RE: Additional Groundwater Delineation Work Plan
Scout Energy Partners
G.L. Erwin A&B NCT 2 Tank Battery
Case No. (1R-254), Incident ID nAUTOfAB000198
Jal, Lea County, New Mexico
Terracon Project No. AR247096

Review of the Additional Groundwater Delineation Work Plan for G.L. Erwin A&B NCT 2 Tank Battery: content satisfactory
On 06/27/2024, a meeting was held between OCD and Scout Energy on addressing this work plan and each item as proposed with agreement from both sides.

EXHIBIT 1
SITE MAP

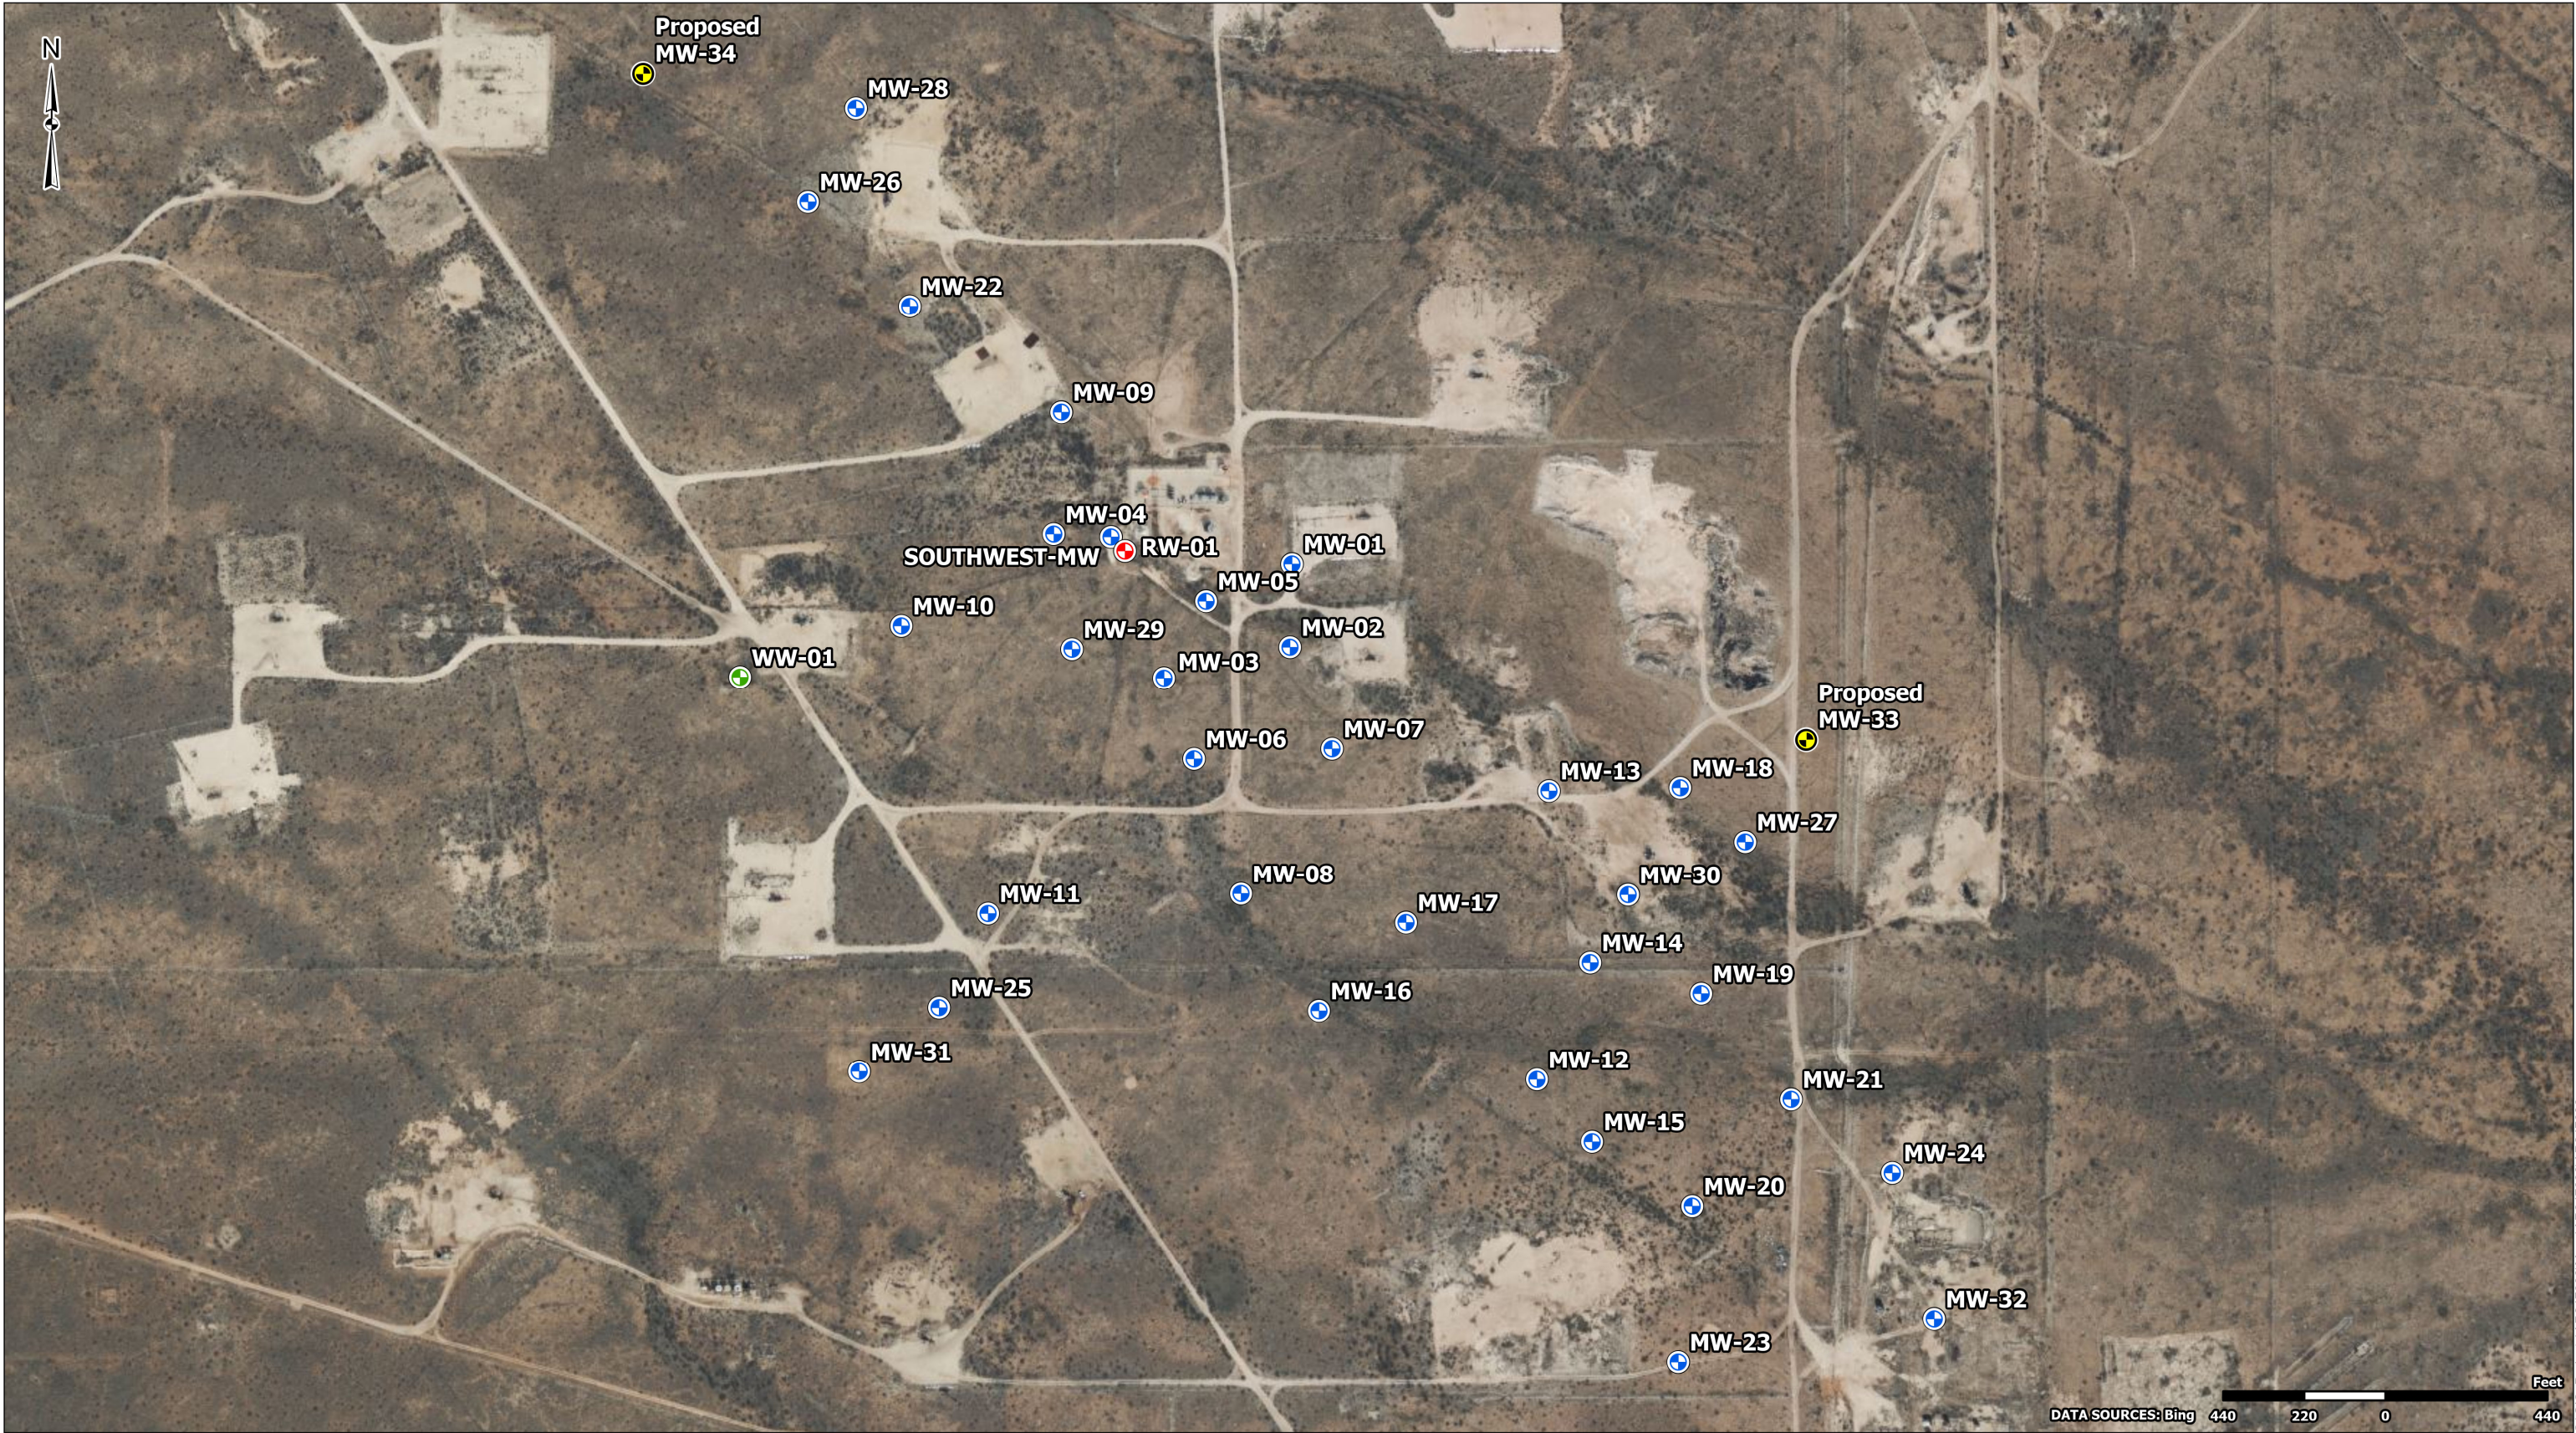
MW-18 and MW-27 have been “dry”, without sufficient water in the wells since 2004. MW-18 has a total depth of 76.98 feet and is screened from 54.5 ft to 74.5 ft. MW-27 has a depth of 48.8 feet and is screened from 25 ft to 45 ft. MW-18 and MW-27 are located approximately 150 feet apart from each other and provide groundwater data for the same area of the site with the goal of defining the eastern extent of the plume. Thus MW-27 was drilled 30 feet shallower than MW-18, presumably to evaluate the presence of a shallow water bearing unit, or “perched” water. Since both wells have been “dry”, it appears there is no shallow water bearing unit in this area. Therefore, we recommend replacing MW-18 and MW-27 with a single well drilled to a total depth of 90 feet and screened from 70 ft to 90 ft. The replacement well will be named MW-33 and placed to the northeast of MW-18 and MW-27 to provide horizontal delineation of the plume as shown on the attached Exhibit 1.

Item 3 requests two monitoring wells be installed upgradient of the plume to provide background groundwater information for TDS, Fluoride, Chloride and Sulfate. We agree with the need to establish clear background concentrations, but we suggest a single monitoring well installed upgradient of the plume will provide the required information. The proposed well will be labeled MW-34 and will be placed northwest of MW-26 as shown on Exhibit 1. MW-34 will be drilled to 75 ft total depth, and screened from 55 ft to 75 ft.

The monitoring wells will be constructed with 20 feet of 2-inch diameter, 0.010-inch machine-slotted polyvinyl chloride (PVC) well screen with a threaded bottom cap and 55 to 70 feet of 2-inch diameter, threaded, flush-joint PVC riser pipe to the surface. The annular space will be backfilled with pre-sieved 20/40-grade silica sand around the well screen from the bottom of the boring to approximately 2 feet above the top of the well screen. A minimum of 2 feet of hydrated bentonite pellets will be placed above the sand pack and cement/bentonite slurry to the surface. The well will be completed with a 4-inch diameter above grade protective casing set in a concrete pad and protected with above-grade bollards at each corner of the well pad. The locations of the proposed monitoring wells are presented in the attached Exhibit 1.

1. NMOCD agrees with all of the outlined items in this work plan and how Scout Energy is proposing to proceed with each one. Please proceed to implement each scope of work as addressed in this work plan. (item 1 through item 3).
